Emissions impossible

Unpacking CSIRO GISERA Beetaloo and
Middle Arm fossil gas emissions estimates

October 2023

Prepared for the NurrDALINJI Native Title Aboriginal Corporation.

Figure 5: Upstream emissions from one GJ of gas from the Beetaloo sub-Basin, delivered to Darwin.

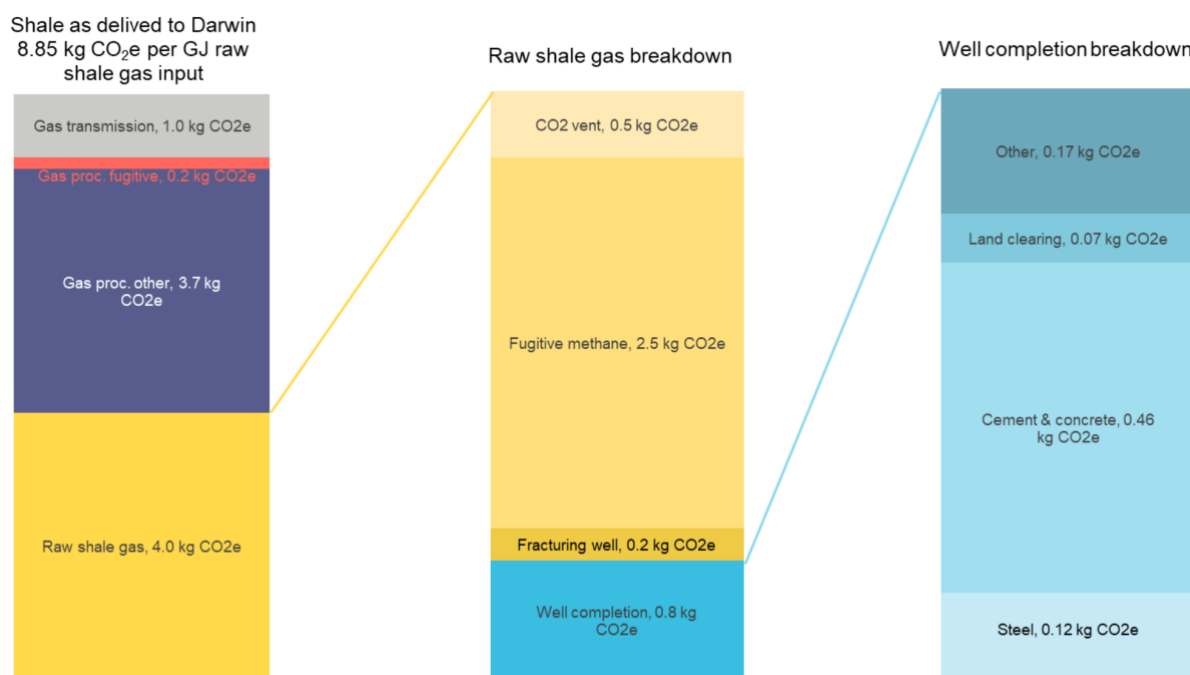
The upstream lifecycle emissions of the shale gas delivered at Darwin are calculated to be 8.85 kgCO₂e per GJ with the model used in the lifecycle assessment. The breakdown is shown in Figure 5.

The calculated upstream emissions are lower than those presented in the Pepper Inquiry. The Pepper Inquiry does not evaluate the emissions from the Beetaloo, but instead incorporates those of a "representative US shale gas field" at 15.5 kgCO₂e per GJ, and 9.1 kgCO₂e per GJ before transport and distribution (Northern Territory Government, 2018a). Accounting for the difference in GWP, the intensity of the gas cited in the Pepper Inquiry is 13.7 kgCO₂e per GJ.

Figure 8: Comparison of the upstream intensity per leakage rate from different sources.

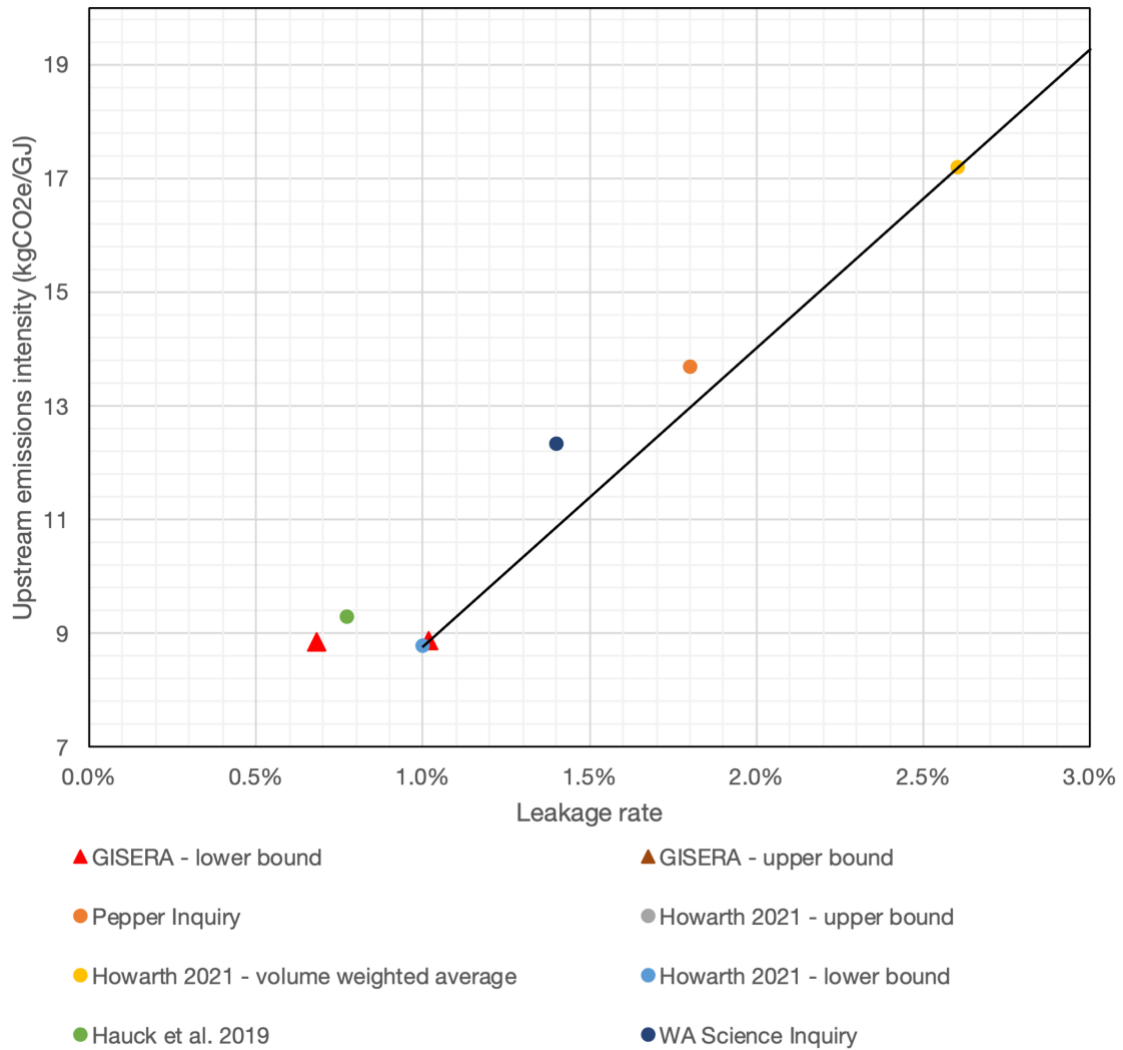
A summary of the comparison of various upstream emissions intensities with different methane leakage rate can be found on the next page.

Figure 13: Upstream emissions intensity comparison, including delivery to Darwin for shale gas in the Northern Territory, before GWP conversion.

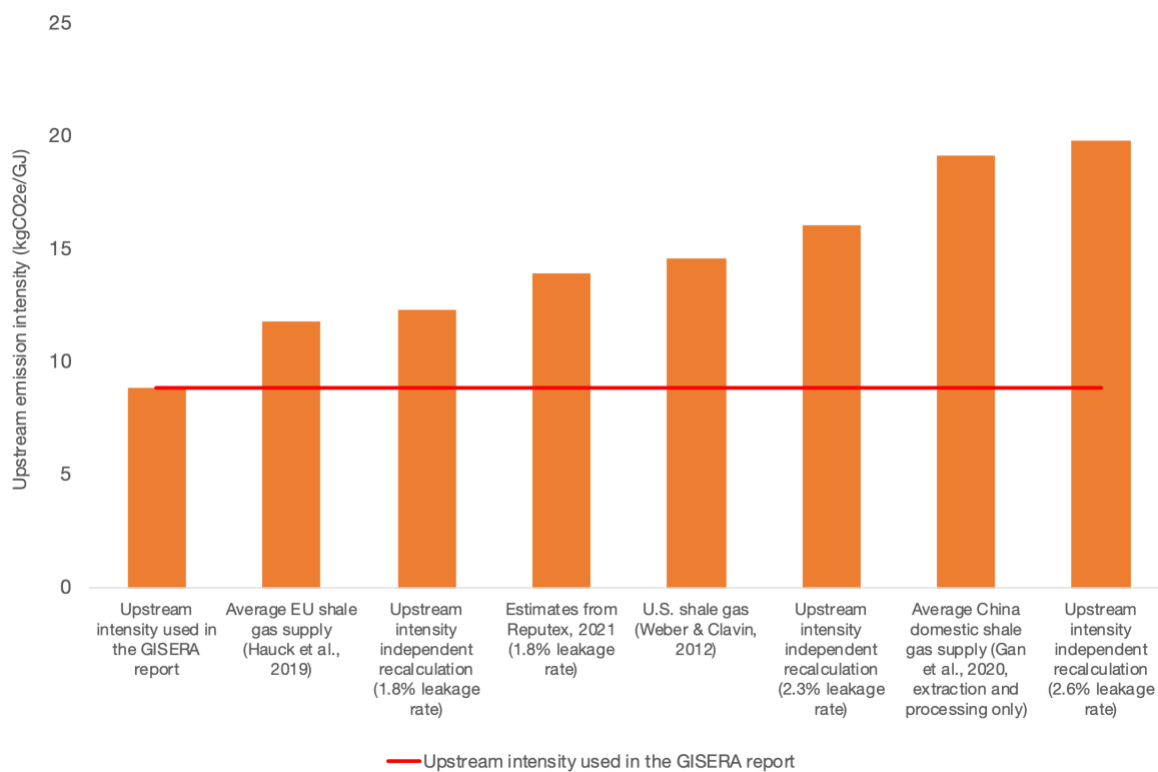
By employing both the findings by Howarth et al. (2021), and the recalculation using the content of the gas, we identified an upstream emissions intensity range of 12.3 kgCO₂e/GJ to 19.8 kgCO₂e/GJ for methane leakage rates comprised between 1.8% and 2.6%.⁵

At a more liberal leakage rate assumption of 3.6%, the upstream intensity can reach as high as 25 kgCO₂e/GJ. These estimates are 1.4 to close to 3 times higher than the estimate from the CSIRO GISERA.
